# SOUTHMOOR RETAIL PLAZA CONDITIONAL USE SITE PLAN COVER SHEET

COVER SHEET  
PROJECT RECORD NUMBER:  
DV-CUSP-20-00003  
DATE PREPARED: 10-16-2020  
PLANS PREPARED FOR:  
**TEBO DEV. CO**

# Summary of Comments on Layout1

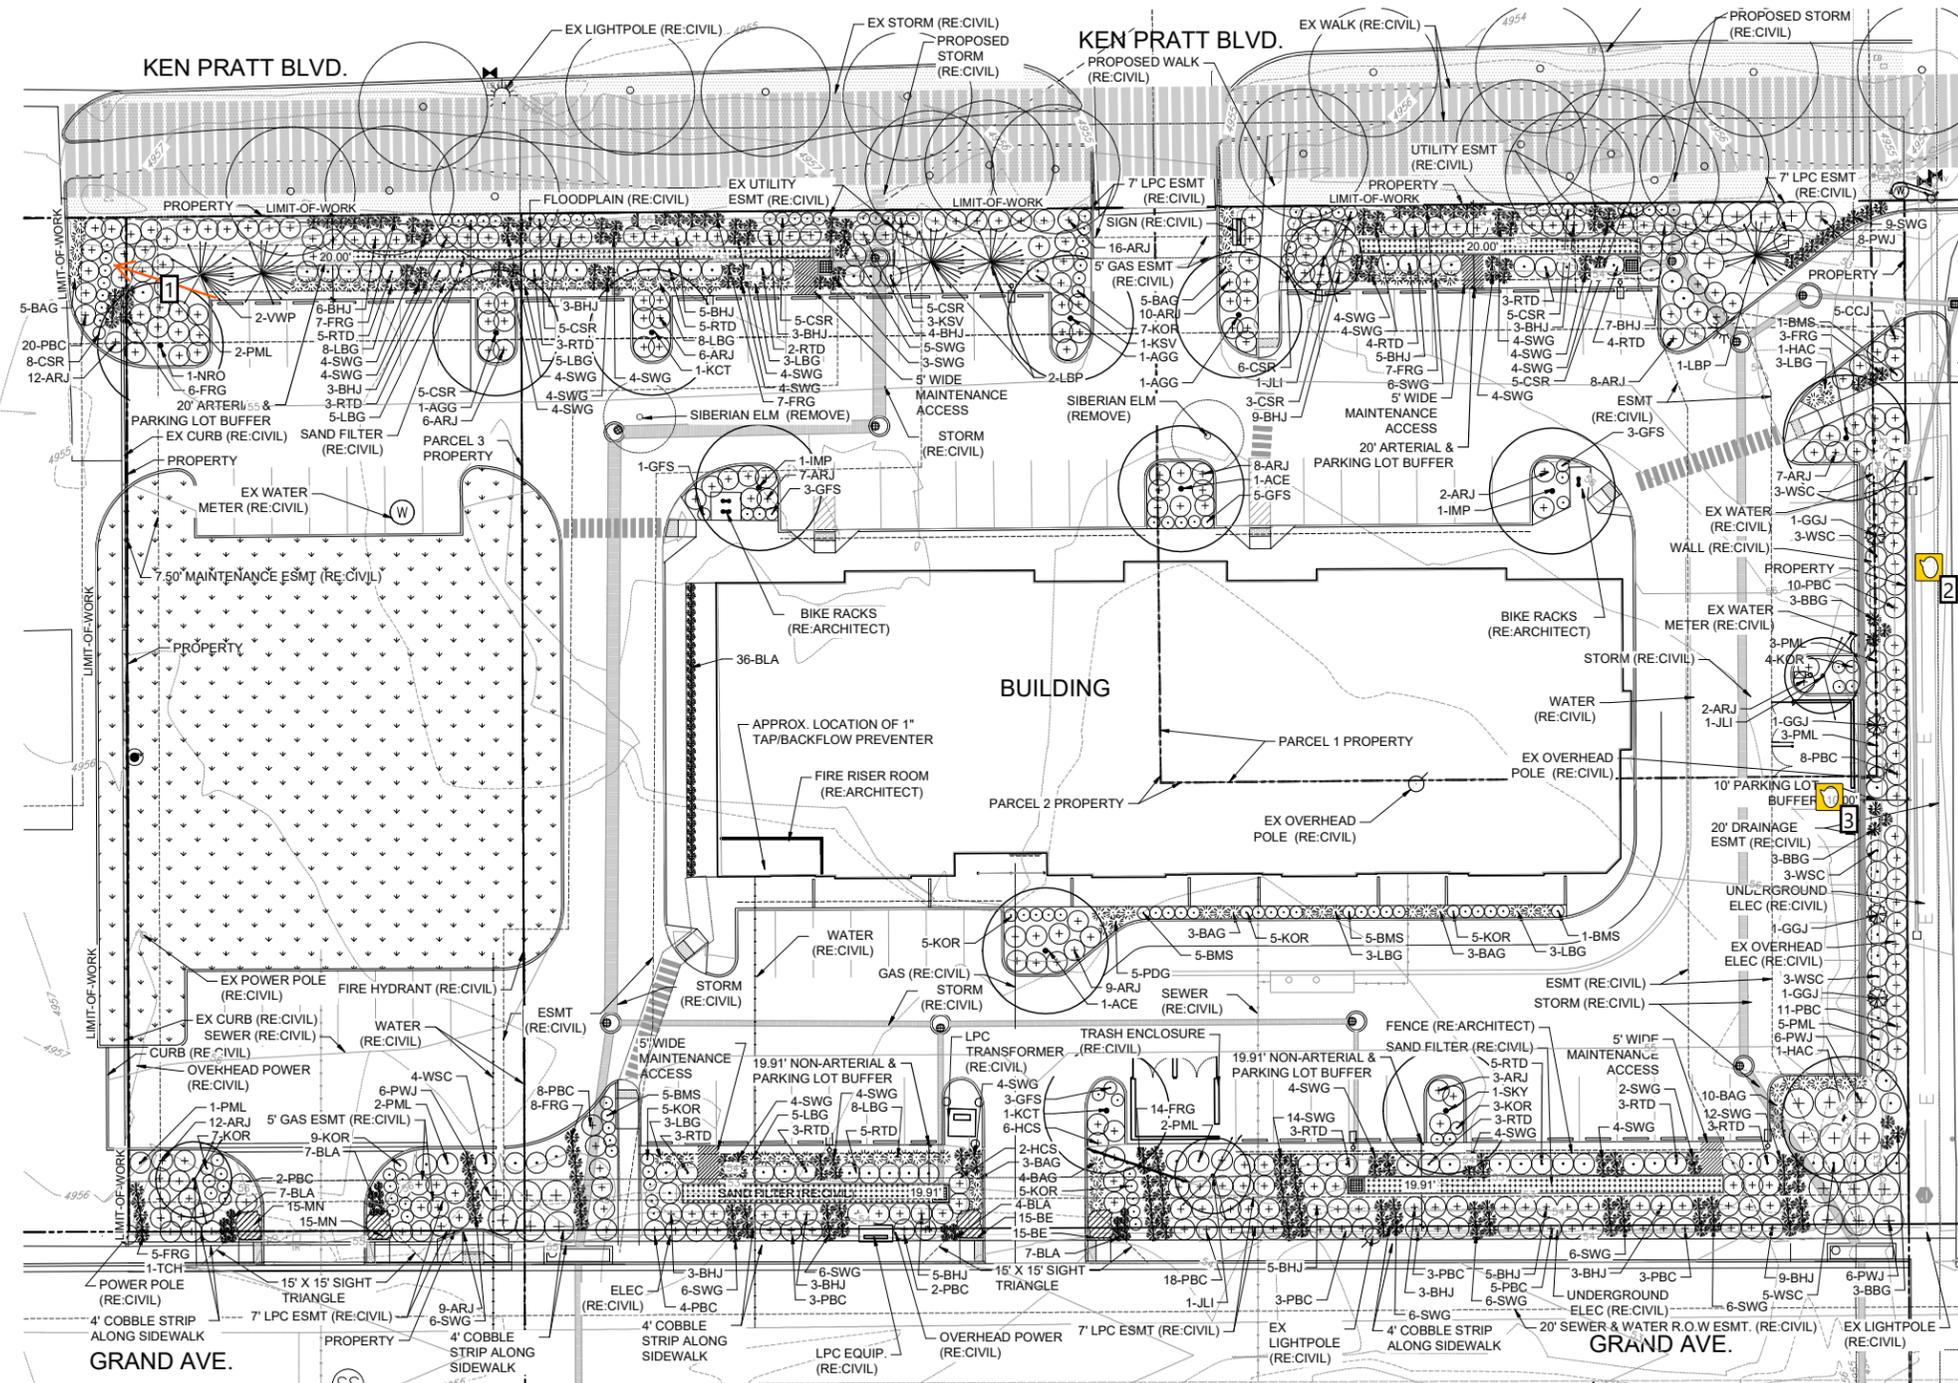
Repeat comment: For all code deficiencies, identify them individually and reference the variance and design exception requests.

These plans remain silent about the variance/modification requests - they should be clearly noted on the plans. Provide a key for each deficiency in this table and add notes below it citing each of the variances/ modifications requested. Or add to this sheet the table which was provided in the letter.

See plan comment - a buffer tree was deleted at west end - why? Expectation is to minimize the deficiencies of buffer landscaping.

## PHOTOMETRIC PLAN

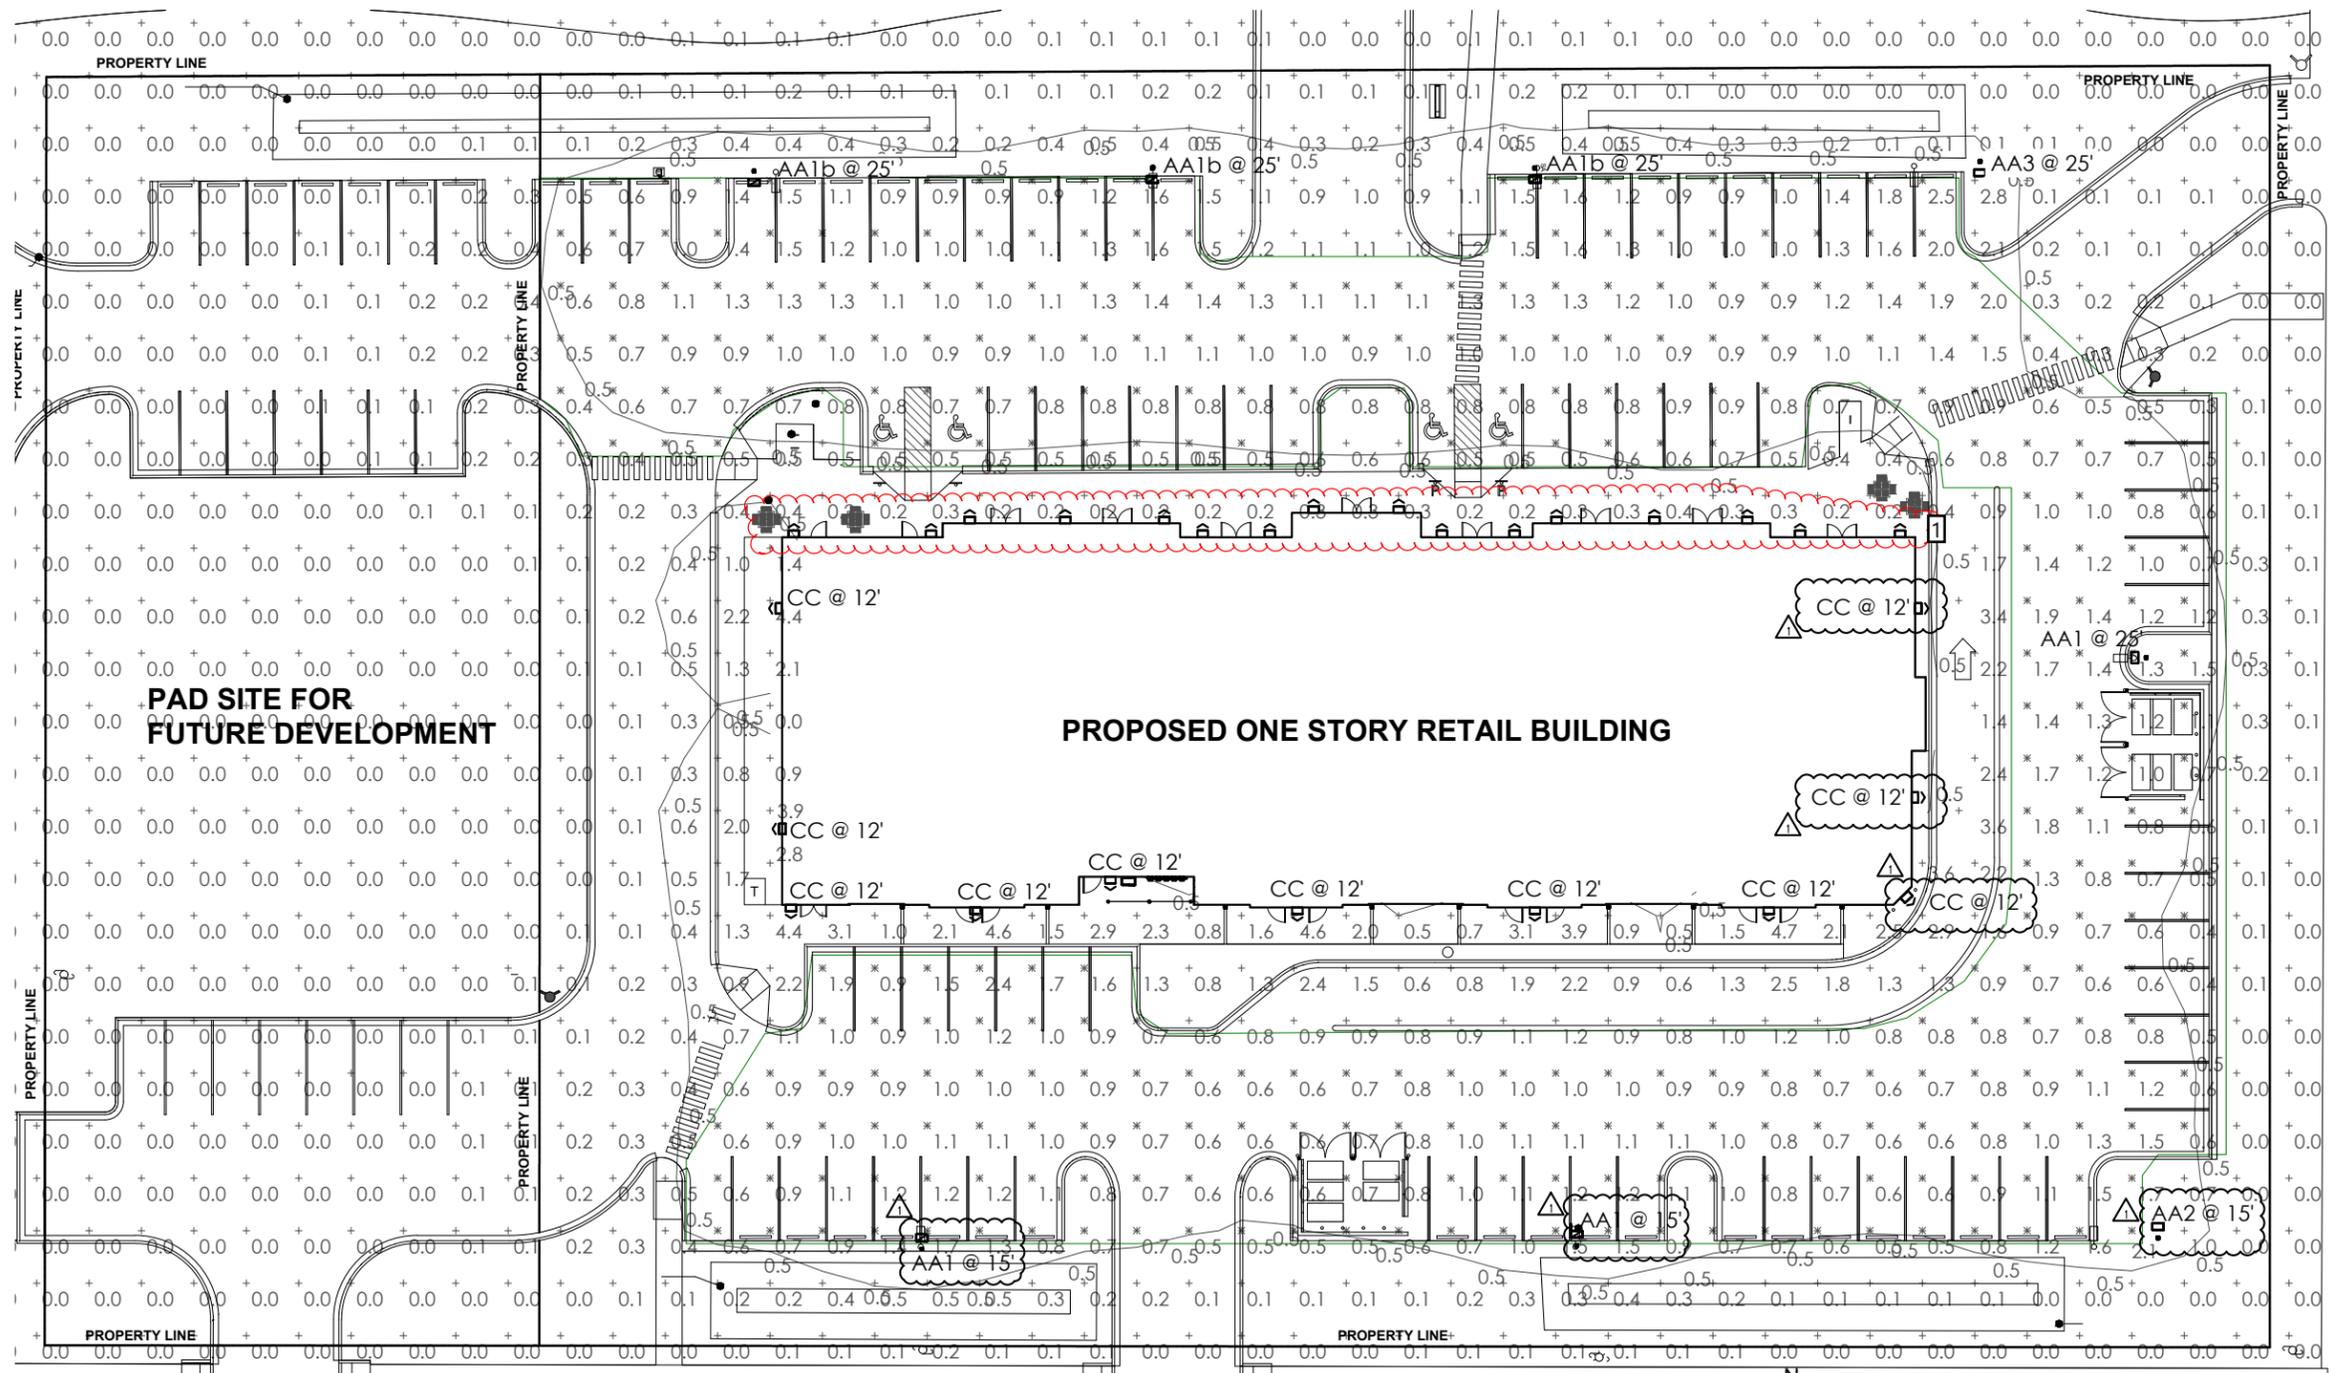
The light fixtures along the front of the building are not accounted for in the list of light fixtures in the table below. Please assign a legend code for these fixtures and add them to the light fixture table below.

Per the lighting plan requirements in the Development Handbook, appendix regarding Lighting and Photometric Plan content, the maximum LLF is 0.1. Please update photometric plan to achieve compliance.
